Flight Procedures Cover Page	Task Action: FLIGHT CHECK	Task Type: SID	Estimated Chart Date: 11/27/2025	APWS Task ID: 376B4447D6CF4CFDB0FF7676383CEC6E	APWS Project ID: 7F957266DAE64EFE9316F32513AAF751
Procedure: CSHEL EIGHT DEPARTURE (RNAV)		Enroute: YES	Specialist: Keefer, John		Agreement Number:
Airport ID: KRSW			Airport City: FORT MYERS		State: FL
Facility ID:	Facility Type:	Flight Inspection Remark Type: New FC Slot

Fort Myers, FL
KRSW
CSHEL DEPARTURE (RNAV)

Subject: Approval Request: Fort Myers, FL (KRSW) CSHEL (RNAV) SID
Non-Standard Chart Note

CSHEL SEVEN DEPARTURE (RNAV)

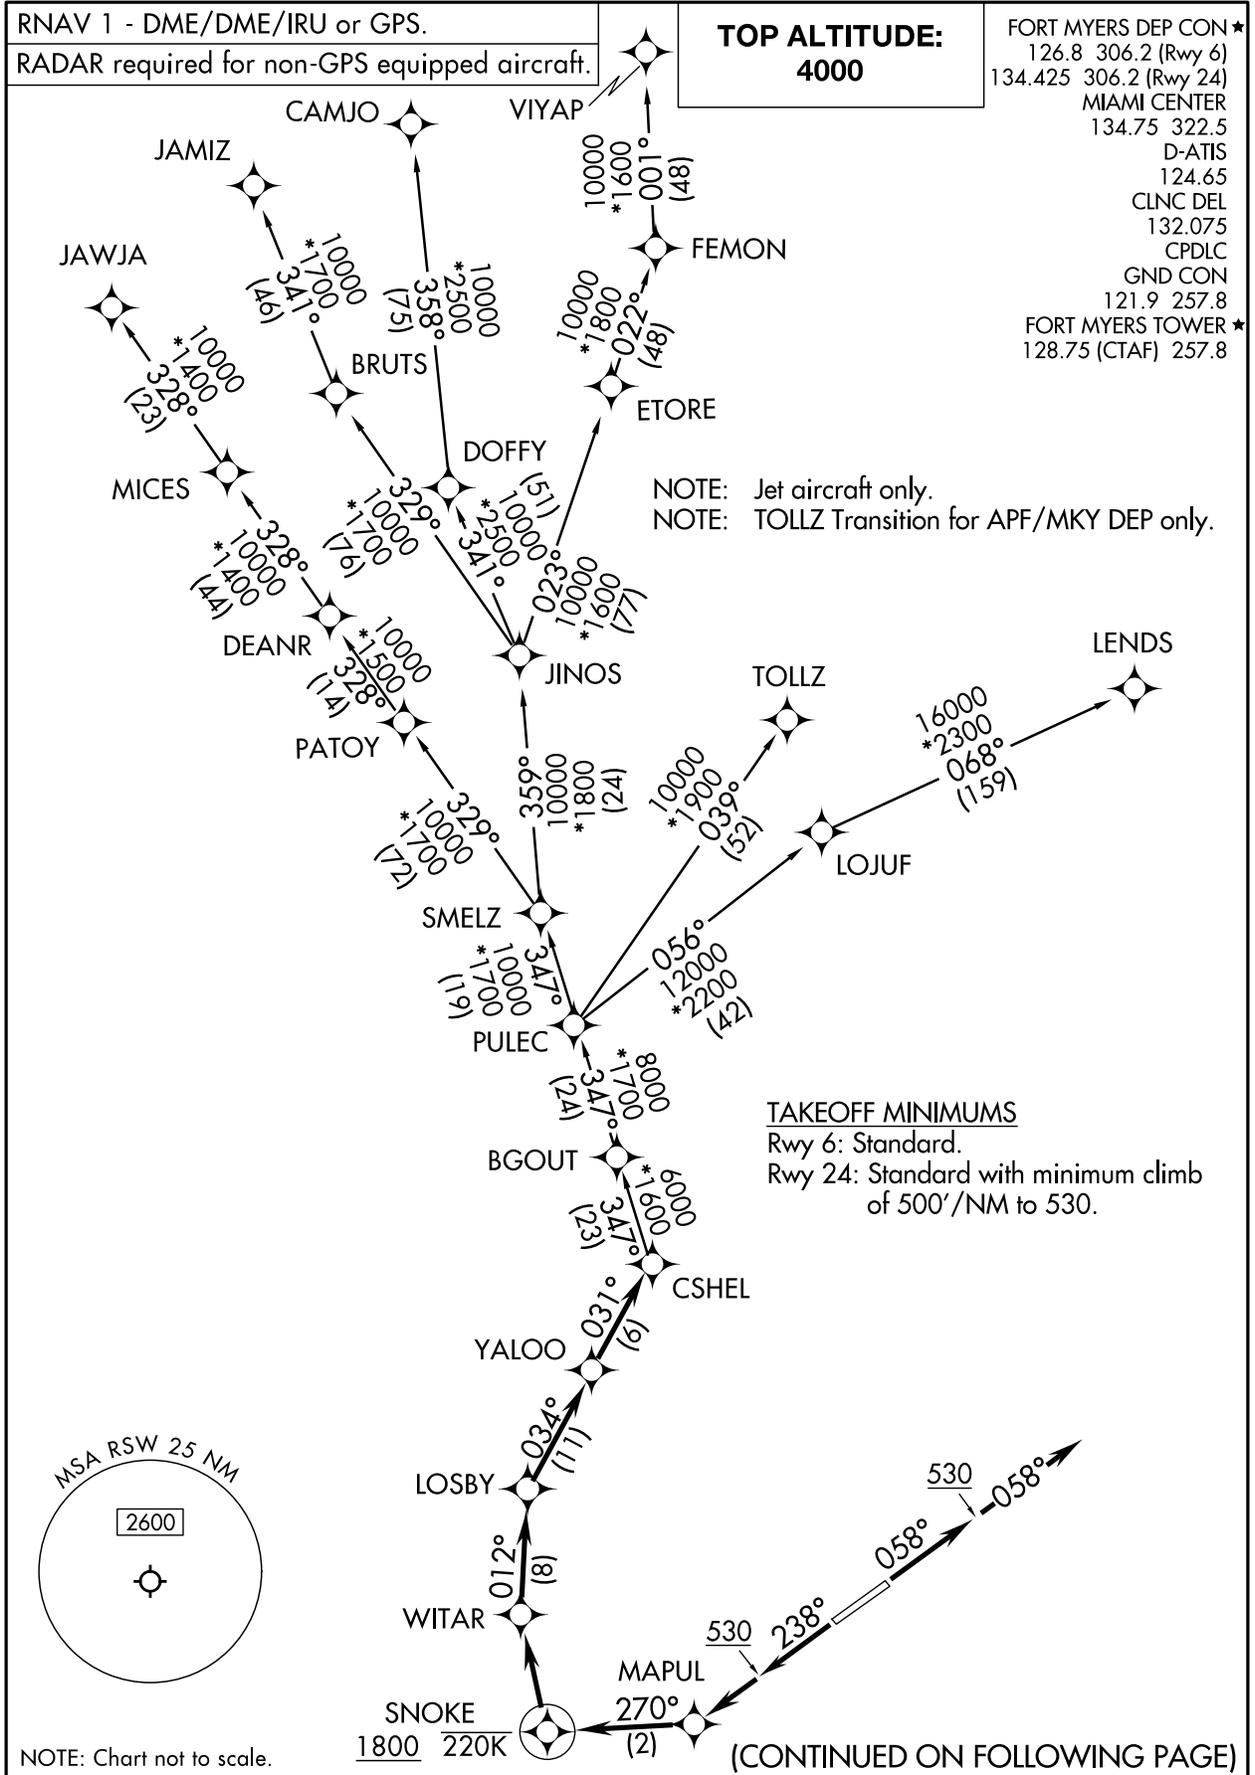
1. DP ROUTE DESCRIPTION: RSW: CHANGED FROM

SOUTHWEST FLORIDA INTL (KRSW):

TAKEOFF RWY 6: CLIMB ON HEADING 058.10 TO 530, THEN ON HEADING 058.10 FOR RADAR VECTORS TO CSHEL, THENCE...

TAKEOFF RWY 24: CLIMB ON HEADING 238.11 TO 530, THEN CONTINUE CLIMB DIRECT MAPUL, THEN ON TRACK 270.00 TO CROSS SNOKE AT OR ABOVE 1800 AND AT OR BELOW 220 KIAS, THEN RIGHT TURN DIRECT WITAR, THEN ON TRACK 012.01 TO LOSBY, THEN ON TRACK 033.80 TO YALOO, THEN ON TRACK 030.74 TO CSHEL, THENCE... TO

RSW:

TAKEOFF RWY 6: CLIMB ON ASSIGNED HEADING FOR VECTORS TO CSHEL ON ASSIGNED TRANSITION. MAINTAIN 4000. EXPECT FILED ALTITUDE 10 MINUTES AFTER DEPARTURE.

TAKEOFF RWY 24: CLIMB ON HEADING 238.11 TO 530, THEN CONTINUE CLIMB DIRECT MAPUL, THEN ON TRACK 270.00 TO CROSS SNOKE AT OR ABOVE 1800 AND AT OR BELOW 220 KIAS, THEN RIGHT TURN DIRECT WITAR, THEN ON TRACK 012.01 TO LOSBY, THEN ON TRACK 033.80 TO YALOO, THEN ON TRACK 030.74 TO CSHEL, THENCE...

... ON ASSIGNED TRANSITION. MAINTAIN 4000. EXPECT FILED ALTITUDE 10 MINUTES AFTER DEPARTURE. - REWRITE PER AFS DIRECTION.

5. THENCE PORTION REMOVE OR INCORPORATED INTO AIRPORT/RUNWAY SPECIFIC ROUTING "...ON ASSIGNED TRANSITION. SOUTHWEST FLORIDA INTL: MAINTAIN 4000. PAGE FLD, MARCO ISLAND, NAPLES MUNI: MAINTAIN: 2000. EXPECT CLEARANCE TO FILED ALTITUDE WITHIN 10

MINUTES AFTER DEPARTURE." - REWRITE PER AFS DIRECTION.
